# - ORIGINATION FORM -

# Proposed Revisions to a Standard Plans Index

Index Number: 641-020 Sheet Number (s): 1, 2, and 5 of 5 Index Title: CONCRETE CCTV POLE

DATED DE	TAILS
nd Rod (See Sheet 5)		
	INDEX	SHEET
	641-020	1 of 5

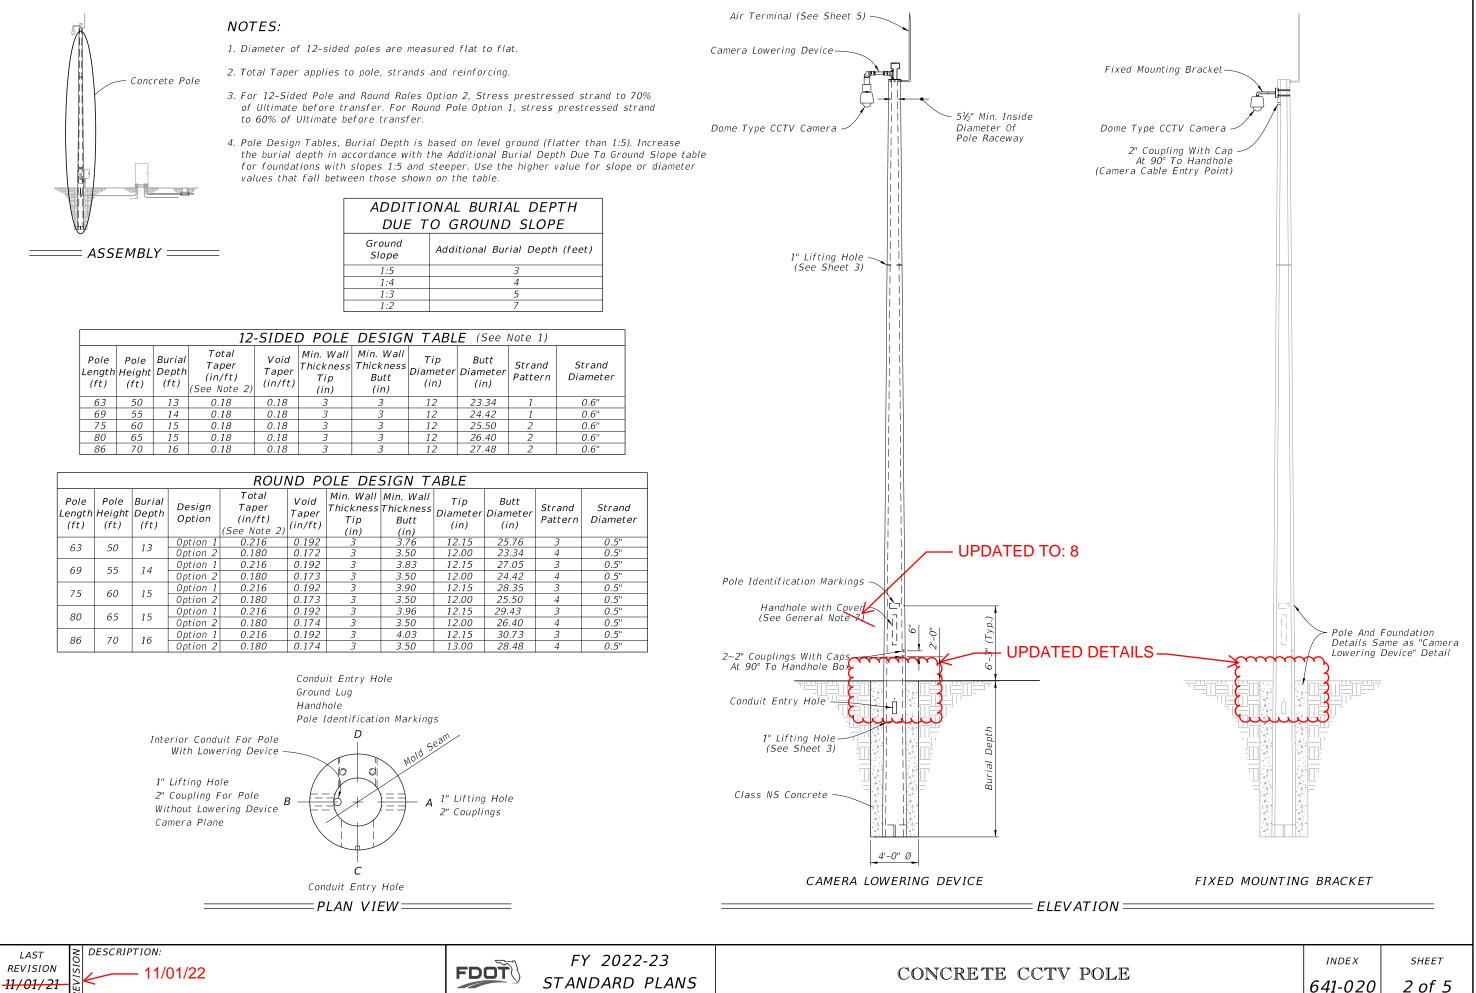
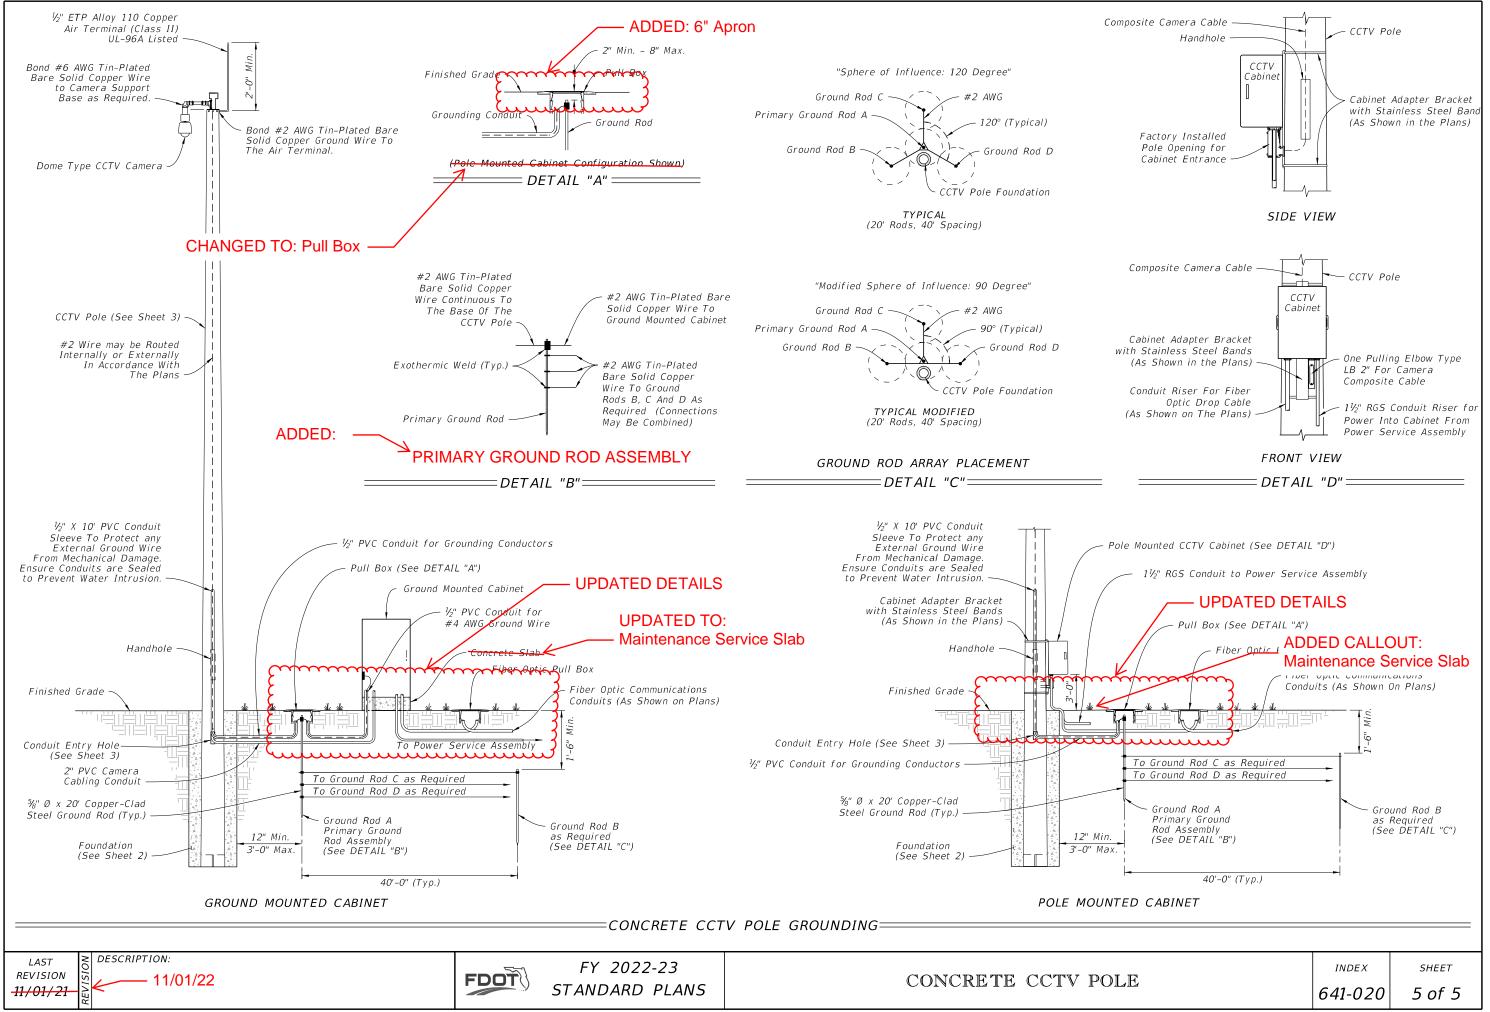
- Sheet 1: Added new General Note 5 (Reference to Index 676-010 for additional details); Renumbered General Notes; Updated the Identification Tag callout reference to "7.G". ; Updated the Ground Mounted and Pole Mounted Cabinet details to show the Maintenance Service Slab in the CCTV POLE ASSEMBLY detail.
- Sheet 2: Updated the Handhole with Cover callout reference to "8" in the CAMERA LOWERING DEVICE detail; Updated the ELEVATION details to show the Maintenance Service Slab.
- Sheet 5: Updated the CONCRETE CCTV POLE GROUNDING detail to show the Maintenance Service Slab in the Ground Mounted and Pole Mounted Cabinet details; Updated the "Concrete Slab" callout to "Maintenance Service Slab"; Added 6" Apron and changed title to "PULL BOX" in DETAIL "A"; Added title "PRIAMARY GROUND ROD ASSEMBLY" to DETAIL "B".
